| Serial No.: | 10/605,726 | Art Unit: | 2813 |

REMARKS

Attachments: Marked up drawings

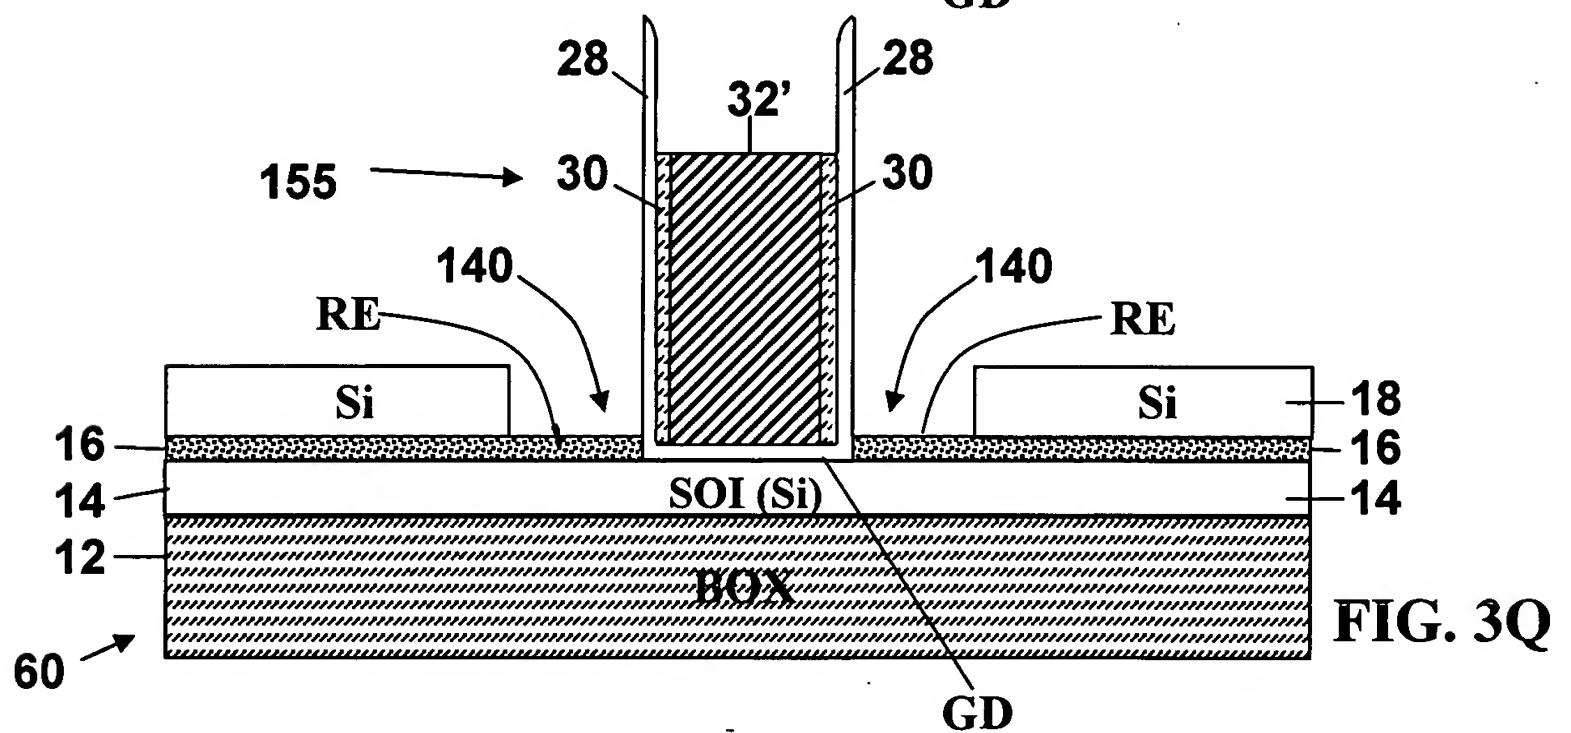
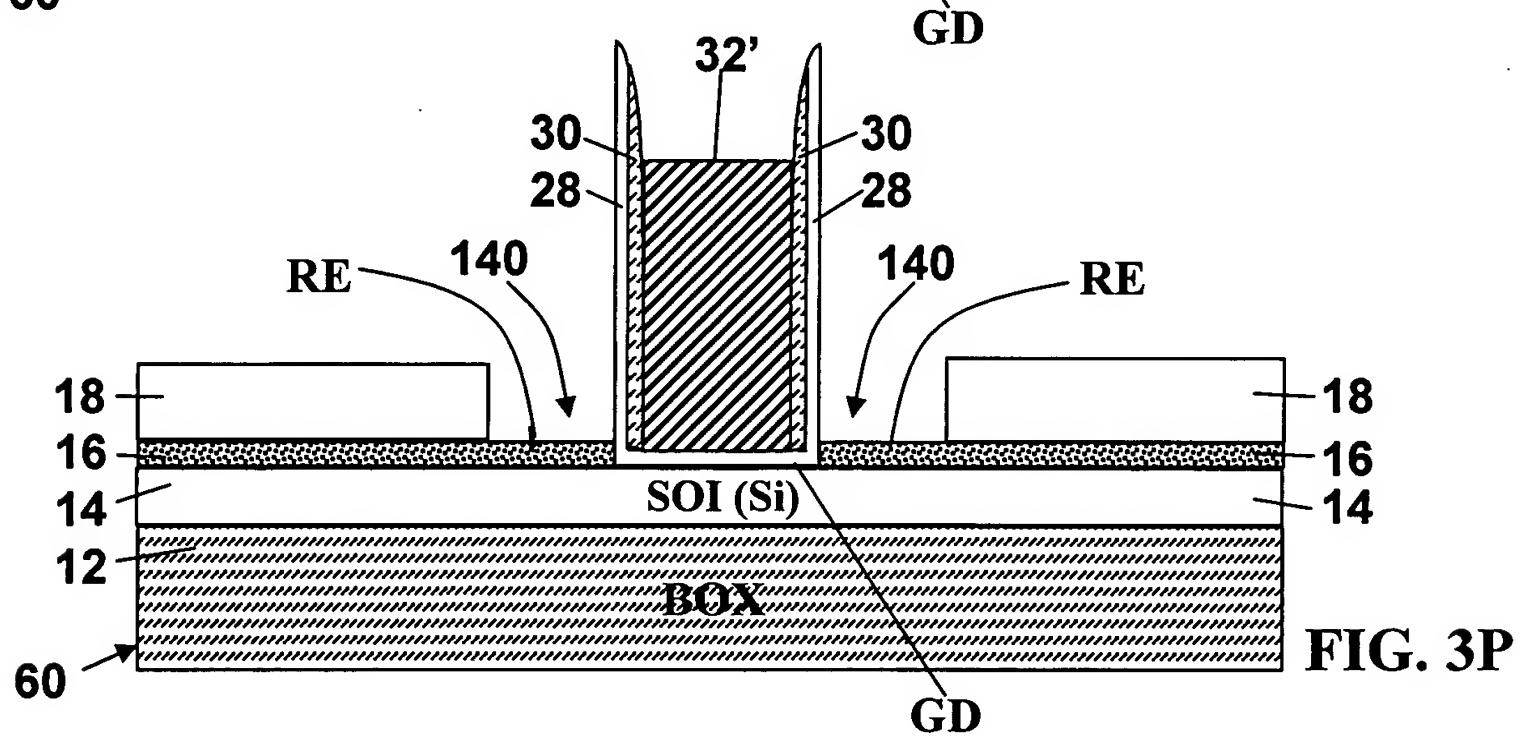
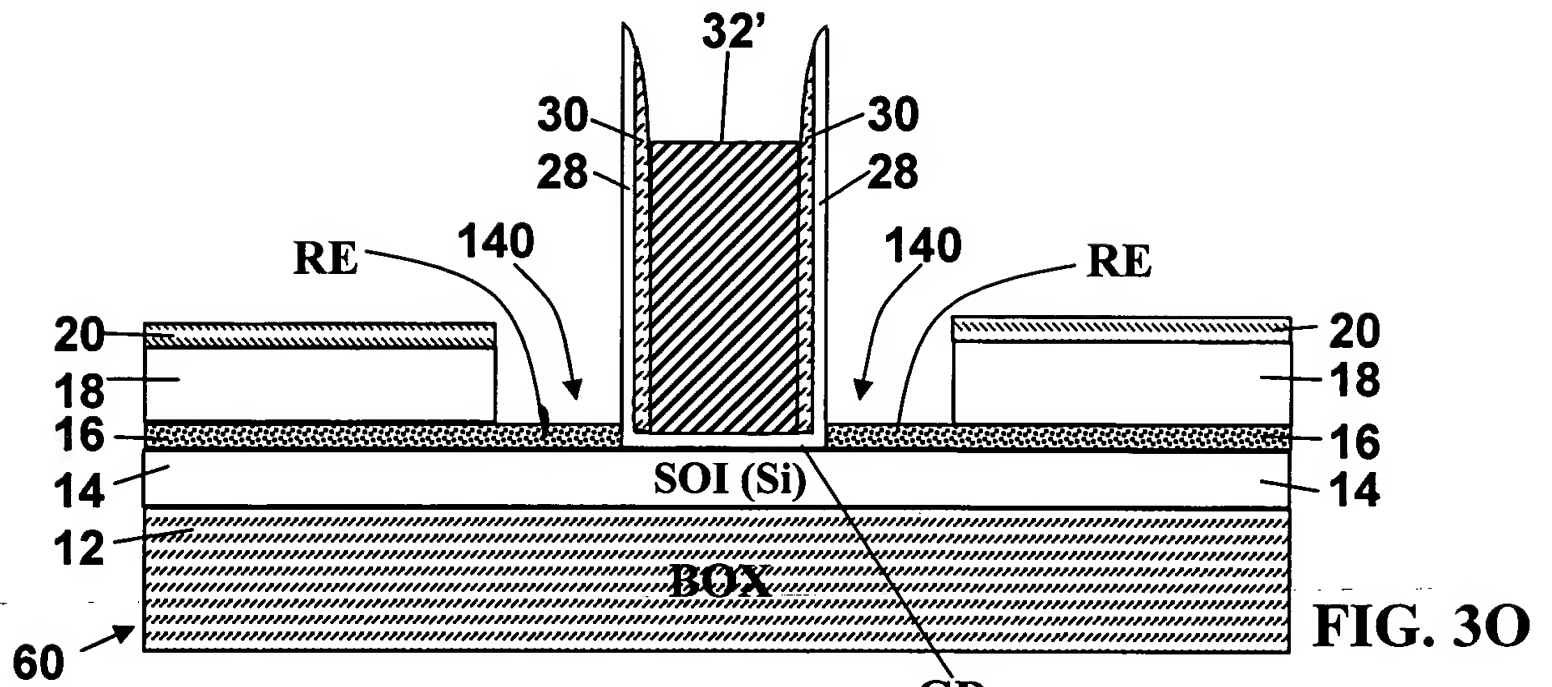
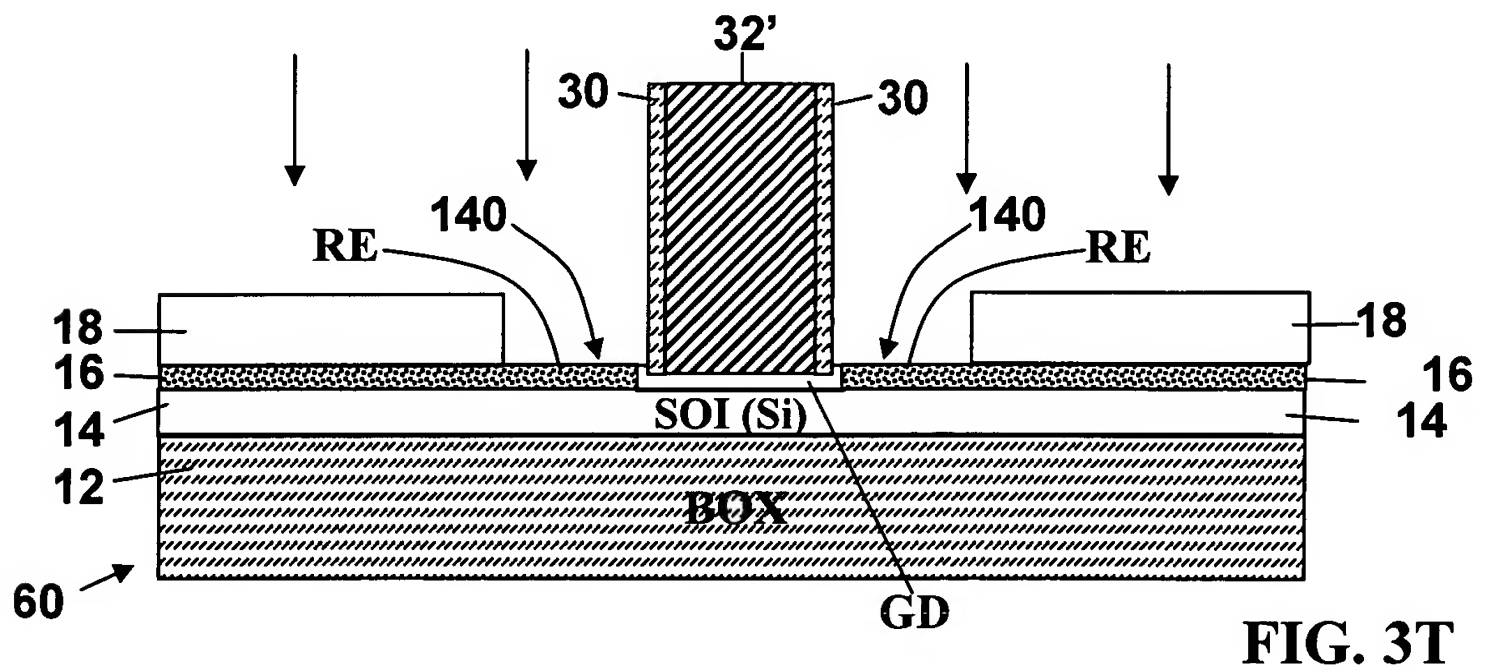
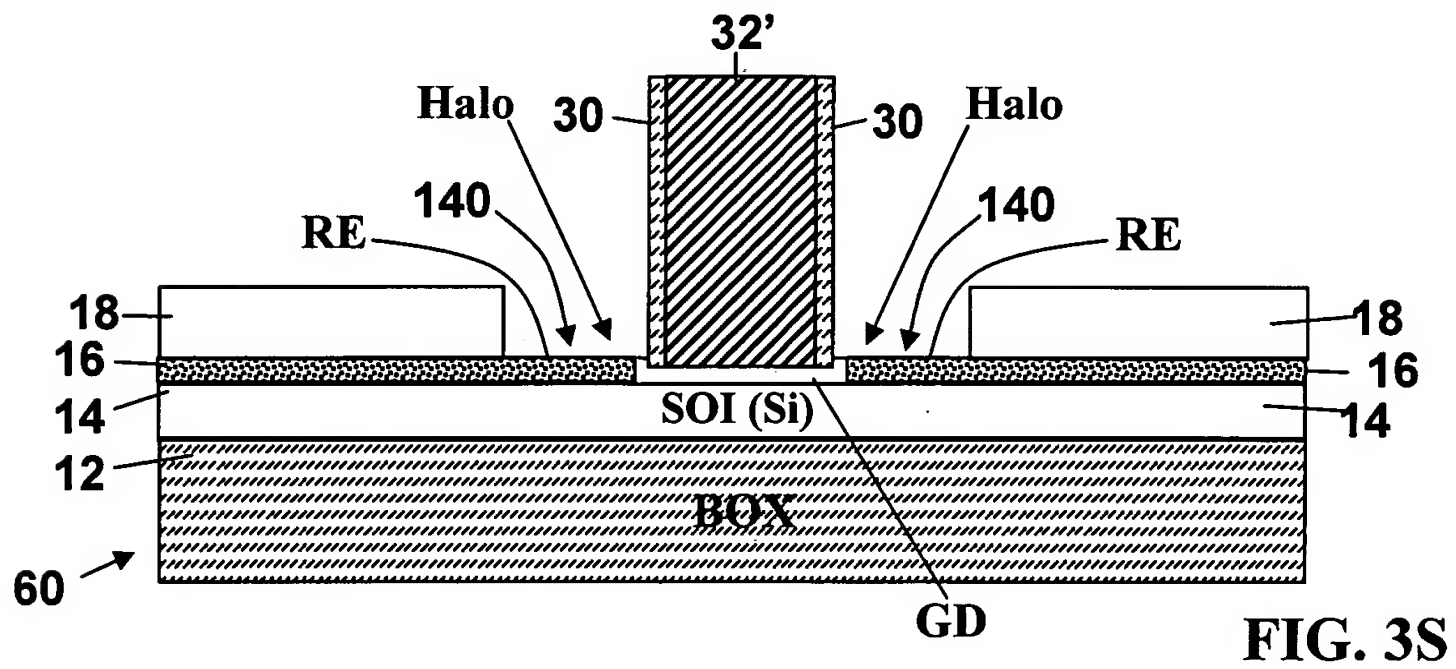
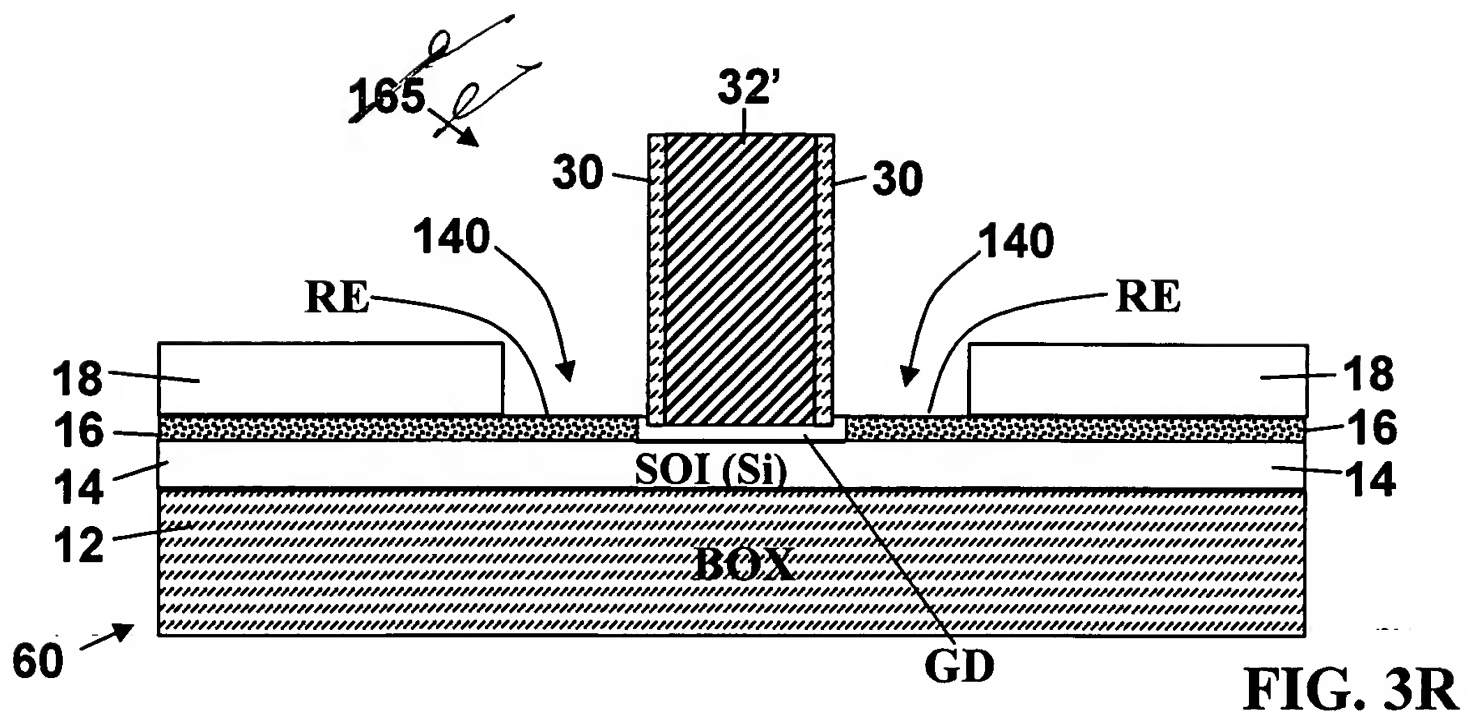
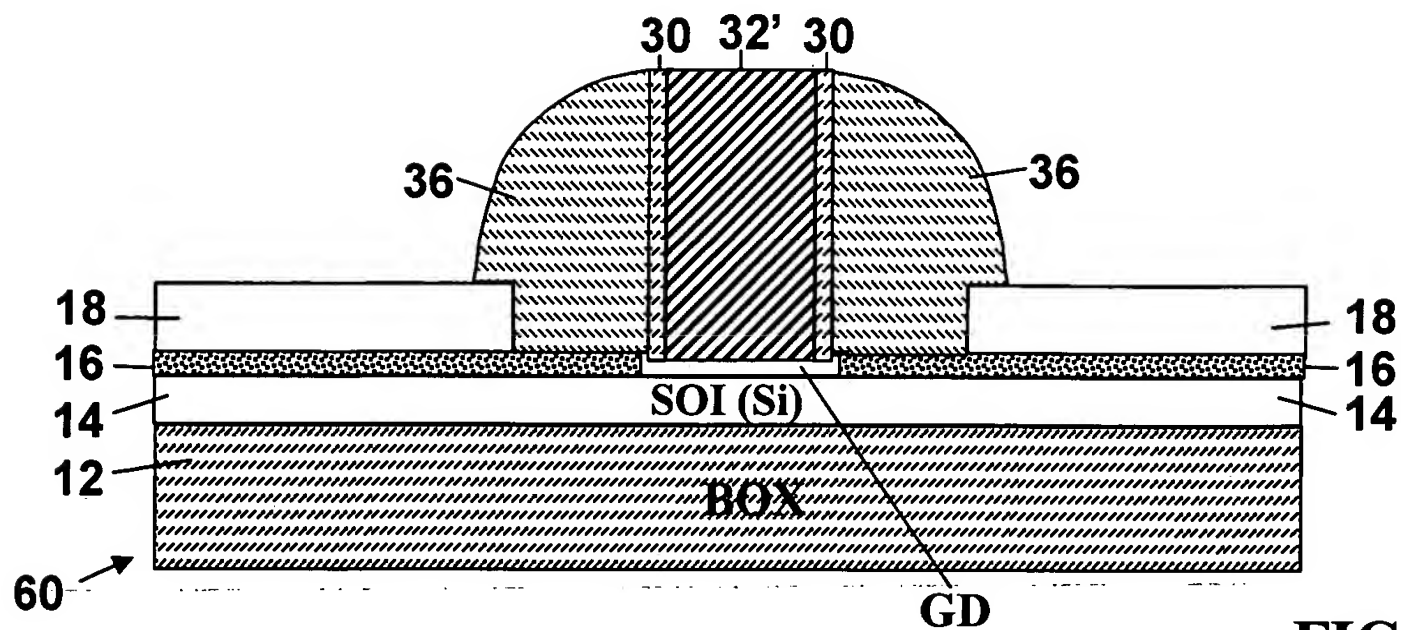
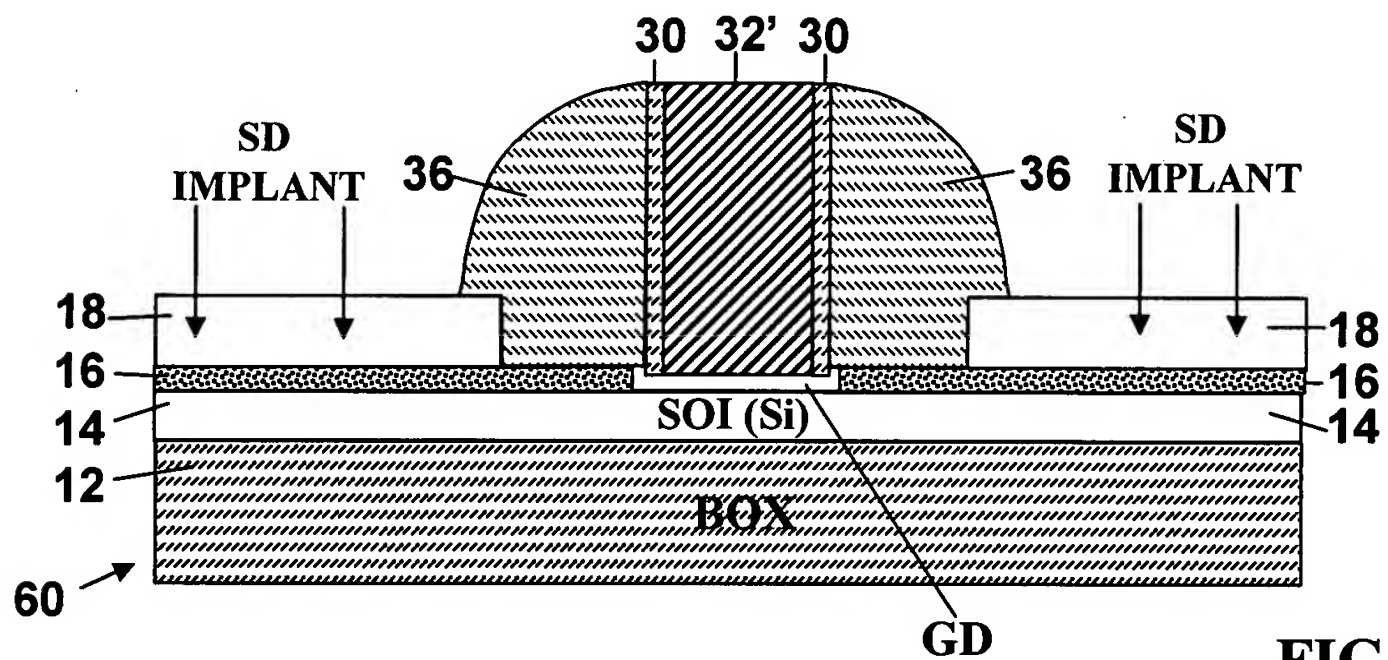
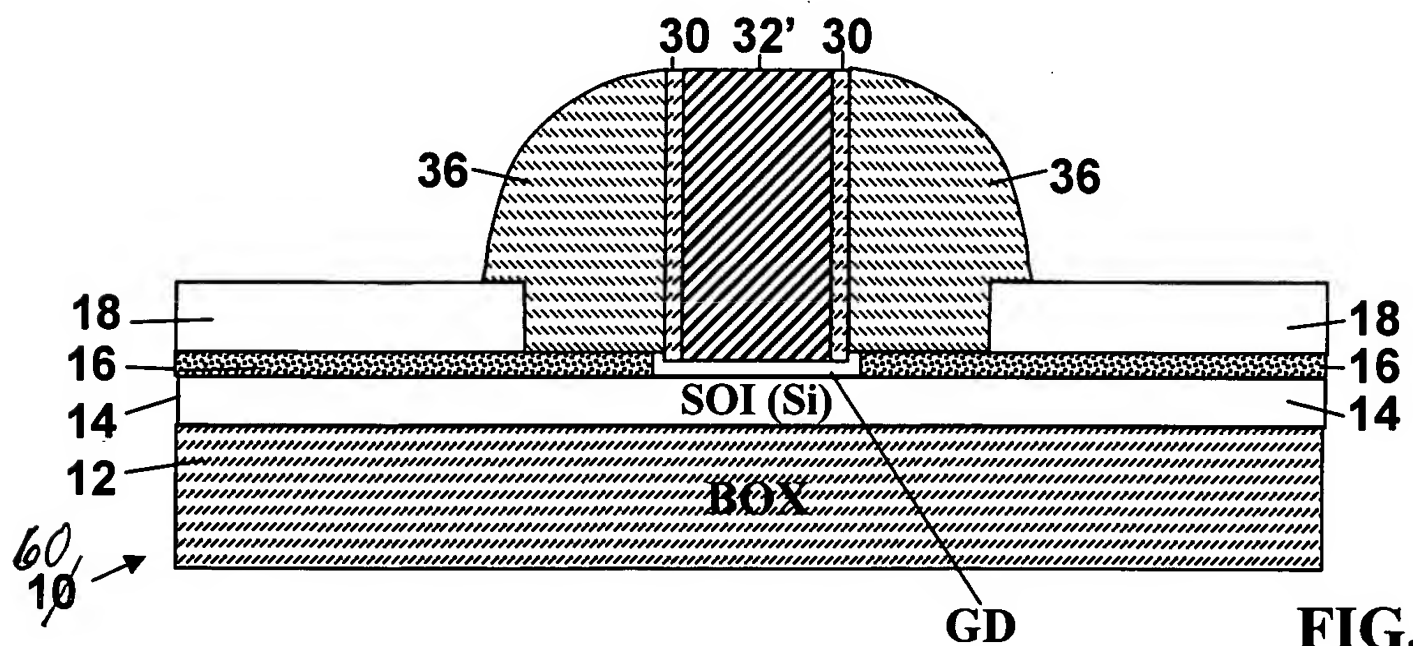
The specification and claims have been amended in view of the Office action and to correct minor errors. Replacement Sheets of the drawings are submitted herewith. Sheets 12-15 of the drawings have been corrected as indicated by the red marks on copies of the original drawings attached hereto. In view of the publication hereof as US 2005/0090066 A1 additional Replacement Sheets are submitted to reduce the intensity of shading so that the lines and legends on the drawings are more prominent and minor improvements in the quality of the lines in the drawings have been made. In view of those amendments and the remarks which follow, the application is believed to be in condition for allowance.
